GENEVA SUITES

DESIGN RECOMMENDATION

SDCI Project: #3020334

1945 Aurora Ave. N.

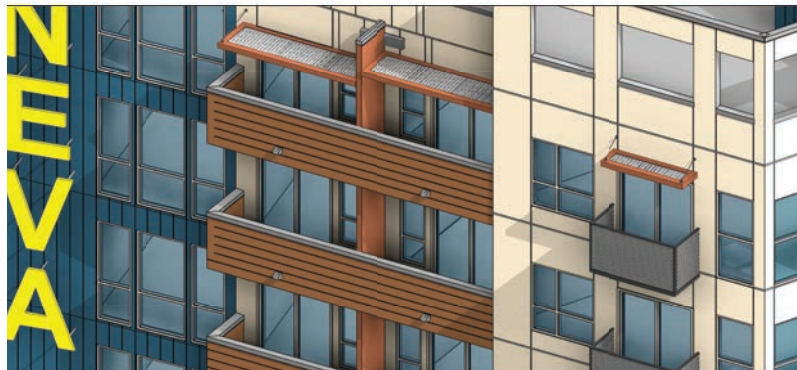
The Board discussed the strengths of the different massing options and strongly supported the hinged massing of Alternate A and the depth with vertical divisions and horizontal balconies shown in Alternate C. The Board preferred a combined massing option which incorporates the hinged massing of Alternate A with Alternate C, as the modified form has the best potential to create architectural presence, address the perceived gateway and respond to the streetscape. The Board directed the applicant to proceed with this modified preferred option. (CS2-A-1, CS2-C, DC2)

- a) Related to the Crockett frontage, the Board supported the projected stair massing element shown in Alternate A and encouraged developing this facade as a corner element to provide a sense of place for the perceived gateway. (CS2-A-1, CS2-C-1, DC2-B)
- b) The Board supported the proposed landscape concept for the roof as shown on page 30 of the packet. Acknowledging that the roof plane will likely be visible, the Board recommended designing the roof as a fifth elevation. (DC2-B-1)
- c) Echoing public comment, the Board requested site sections to clarify the relationship to context and the visibility of the roof for the next meeting. (CS1-C, DC2-B-1)

To reduce the perceived mass, the building design strategically uses decks, recessed elements, and highlighted building entries.

The most visible facade of the building is the one facing the street. Particular attention will be paid to this side. However, the design will be consistent on all sides of the building including the roof which will be carefully landscaped and it will be treated as the 5th elevation.

An alternate to the open frame at the roof amenity area is shown to the right.

Response to 2.b-2.c (DC2, DC4, DC2-B, DC2-C, DC4)

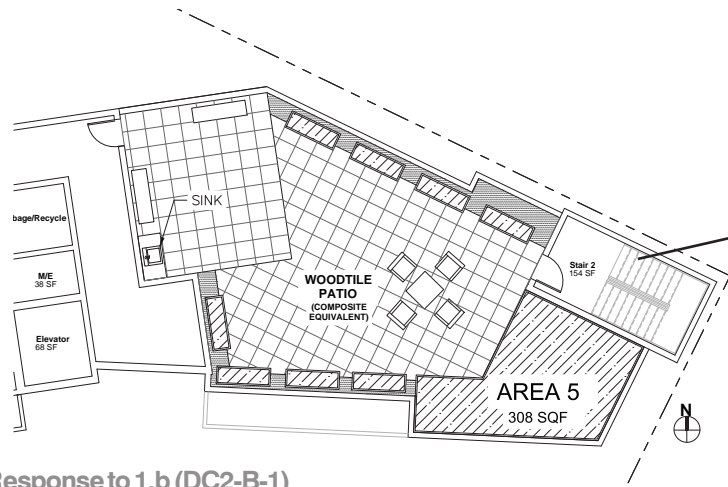
- a) The Board supported the windows at the elevators as they provide façade interest and daylight access and recommended incorporating more windows, where possible, along the Aurora and Crockett frontages. (CS1-B-2, DC2)
- b) For the upper level balconies, the Board viewed the design of the guardrails as an opportunity to create an interesting cascading feature and recommended strengthening the connection between the guardrail design with the green wall feature in order to create a holistic design. (DC2, DC4)
- c) The Board supported detailing of the recessed walls and balcony soffits in a way that is differentiated from the cascading balconies and recommended a simple expression. (DC2-B, DC2-C, DC4)

The Aurora Ave N facade is broken into five elements (A-B-C-B-A) that project, recede and vary in material and color. The intent is to provide a facade readable at multiple levels: driving by at 40 mph and walking by. There are full length windows on the elevator lobby providing more natural lighting to the lobbies on each floor and creating a shaft of glass and light at the center of the facade. There are two green screen treatments proposed. The first continues the horizontal effect of the balcony siding. The second overlays the balconies and the Level 1 facade with a mesh green screen.

Response to 3 (DC-B-2, DC2-C, DC2-D, DC4-C-1, DC4-D-1)

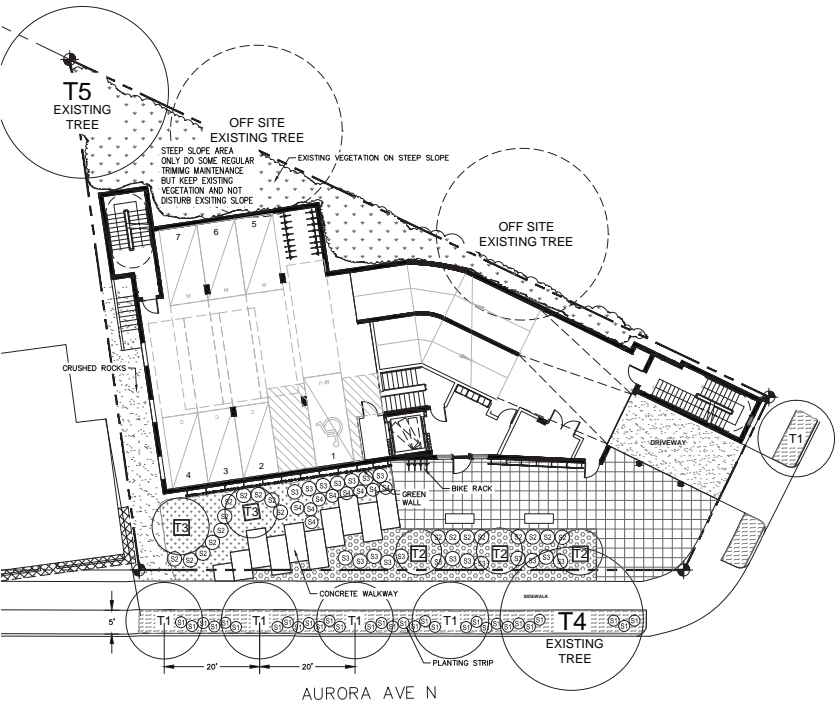
The Board agreed the green wall should read as part of the building identity instead of an applied screening and recommended designing the green screen/ wall as an expressive architectural feature. The Board strongly supported the character represented on page 30 of the packet and gave direction to incorporate modulation, variety, variation and layered planting into the design, similar to what is shown in the precedent images. Related to this feature, the Board indicated preliminary support of the requested departures, provided that the green screen/ wall is further developed as a special architectural feature. The Board requested more information about the green screen/wall detailing for the next meeting. (DC2-B-2, DC2-C, DC2-D, DC4-C-1, DC4-D-1)

The Board agreed that site lighting should be incorporated to provide a well-lit entry way for the recessed elevation and encouraged wash washing lighting to highlight the green screen/wall element. The Board requested a lighting plan, mindful of night light pollution and glare impacts, and a signage plan and street level perspectives for the next meeting. (DC4-B, DC4-C-2)

As noted, there are two green screen alternates proposed to cover the blank facade. We feel it's visibility doesn't justify an elaborate green wall, such as on page 30 of the EDG packet. The mesh alternative is simpler and will provide a better base for vegetation. Visually, it also, creates another dimension on the facade. No Standard Departure is required for the blank walls since there are no blank walls greater than 40 that are not covered with screening and landscaping on the wall itself per 23.47A.2.a.5)

A light plan by the Landscape Architect has been submitted. A signage concept will be provided at the DRB meeting.(See p.26)

DEPARTURE #2

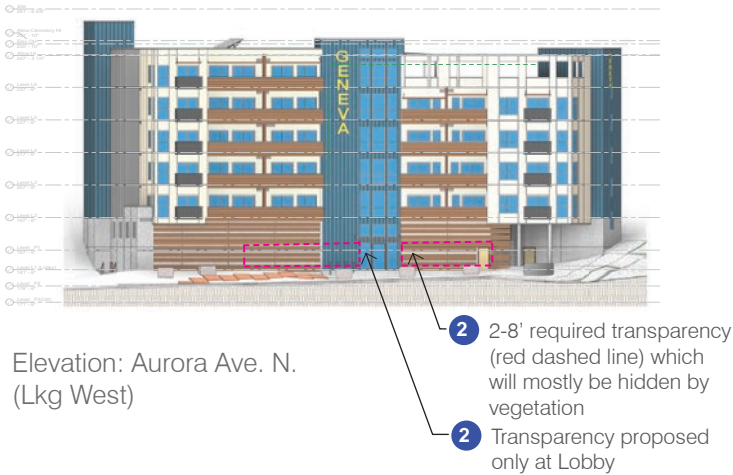
Front Setback (SMC 23.47A.008.A.3): The Code requires street Level facades within 10' of street lot line. The applicant proposes a setback between 15'-6" to 21'-2" of the streetlot line. The Board indicated preliminary support of the request provided that pedestrian lighting, bicycle racks, pedestrian amenities are incorporated. The Board recognized that the departure has the potential to create enhanced open space and a better transition from Aurora Ave. The resulting design has the potential to better meet Design Guidelines CS2- B-2 Connection to the Street, PL1-A-1 Enhancing Open Space and DC3-A Building Open Space Relationship.

Street Level Transparency (SMC 23.47A.008.B.2): The Code requires 60% of the street facing facade between 2 feet and 8 feet above the sidewalk to be transparent. The applicant proposes less than 60%. The Board indicated preliminary support of the departure as long as the design of the green screen/wall is further developed as a special architectural feature. The resulting design has the potential to create a sense of place and better meet Design Guidelines DC2-A, Architectural Concept Massing, DC2-D-2 Texture and DC3-A Building Open Space Relationship.

- 1 Front Setback. Allow greater then 10' setback from Aurora Ave N. property line
- 2 Transparency. Only transparency on Aurora Ave. facade is at building residential lobby entrance.

- 1 Building is setback to 15'-6" to 21'-2" which sets it back the required distance from a city drain line and easement; allows greater separation from Aurora for units and for parking garage entrance which will provide the opportunity to create enhanced open space and a public area more welcoming to pedestrians and a better transition from Aurora Ave to building entrance; enhances both pedestrian an vehicular safety (Refer to guidelines CS2, PL1, PL2 & PL-3)
- 2 Transparency adds no benefit to the facade which is setback from the street with extensive landscaping in front of it. It would be a distraction to vehicles moving south at 40-50 mph. Commercial uses at this location are virtually inaccessible and would not add to the architectural context and character of the neighborhood, interaction, or connectivity. (Refer to Guidelines CS3, PL1,& PL3)
